**EPA    Superfund  
Explanation of Significant Difference  
for the Record of Decision:**

**Selma Treating Co.,  
Selma, CA  
4/18/1997**

EXPLANATION OF SIGNIFICANT DIFFERENCES  
DECLARATION

Selma Pressure Treating Superfund Site  
Selma, California

FIGURE 1

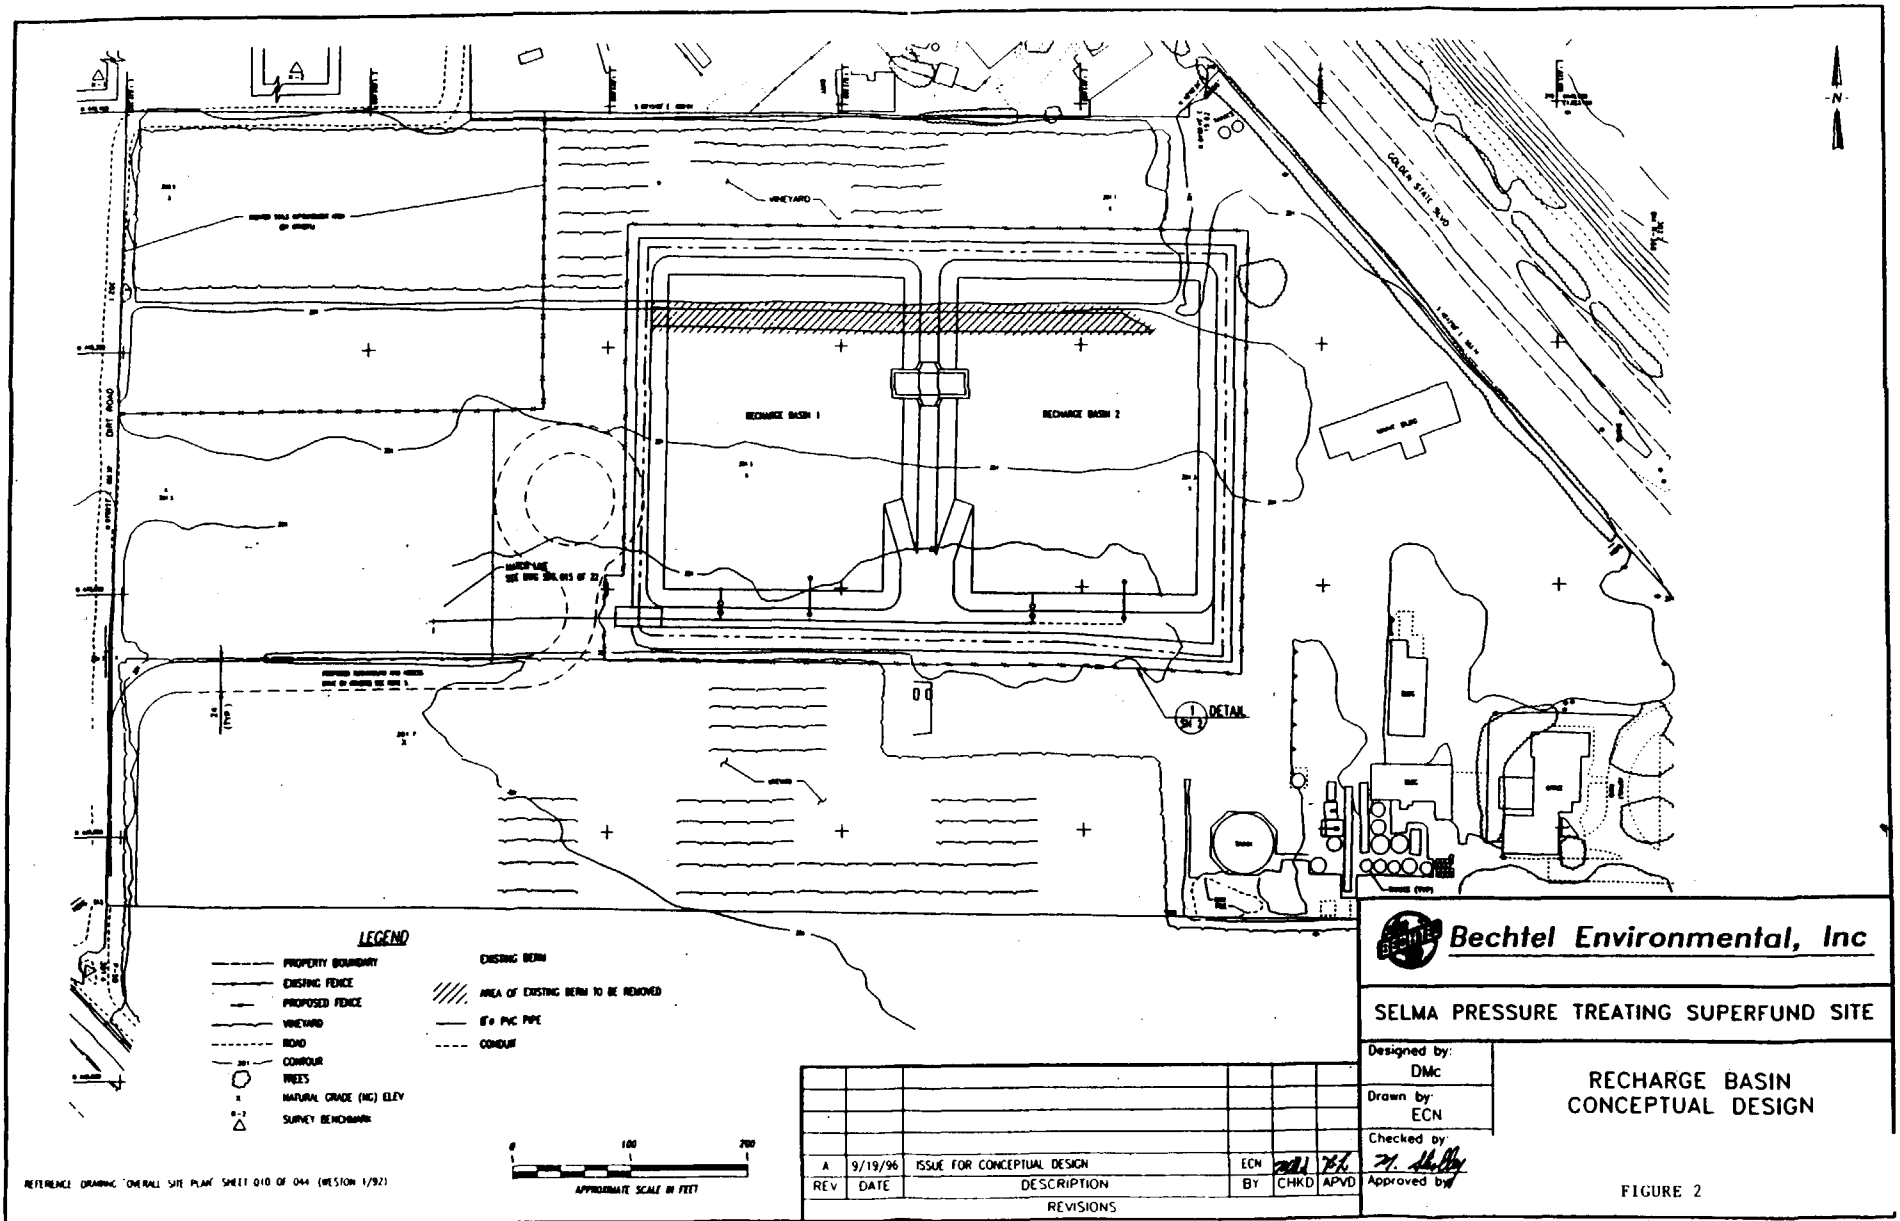
In light of the factors discussed above, EPA has determined that a percolation pond recharge system is the preferred method for returning treated effluent to the aquifer at this Site. DTSC has also accepted the concept of percolation over reinjection for this Site. Such change will be implemented by a percolation system which will discharge treated effluent into two percolation ponds. The dimensions of each pond are two hundred feet by two hundred sixty feet (200'x260'). The ponds will be located approximately four hundred feet east of the western site border, and two hundred to four hundred south of the northern site border. See Figure 2.
